## APPENDIX 2

### Agency Correspondence

**Re: SSD-10432 - Response to Council Submission re Traffic (Your Ref xxx )**

TIA Addendum Report – Prepared by GHD

Figure 1 Intersection arrangement

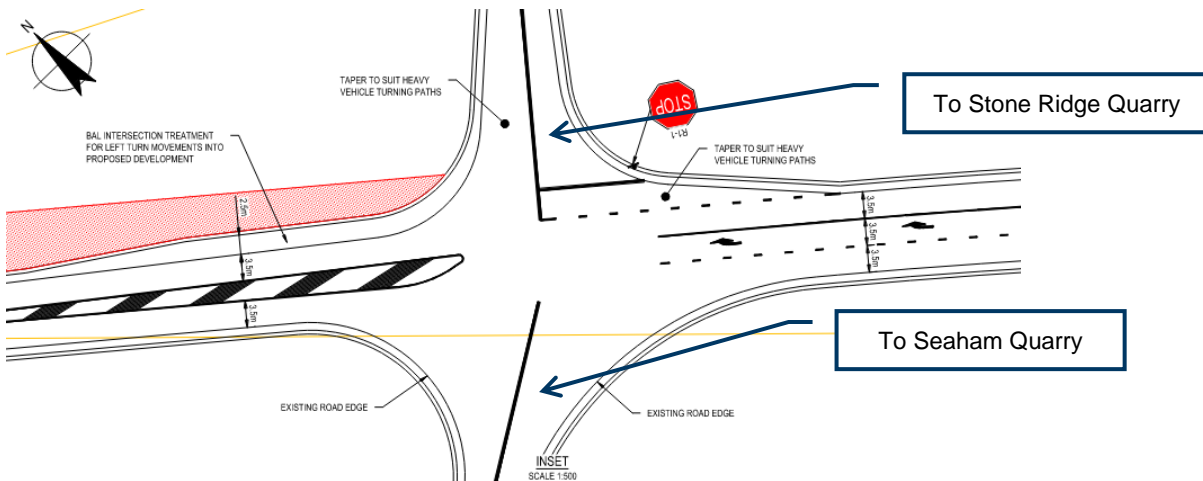
- The TIA Addendum considers updated traffic numbers provided by Boral's future expansion application to demonstrate performance at the site access.
- The Stone Ridge Quarry access will utilise the existing Hamburger Trail, which is located directly opposite, and north of, the existing Seaham Quarry access. Together the two accessways would form a cross-intersection with Italia Road.
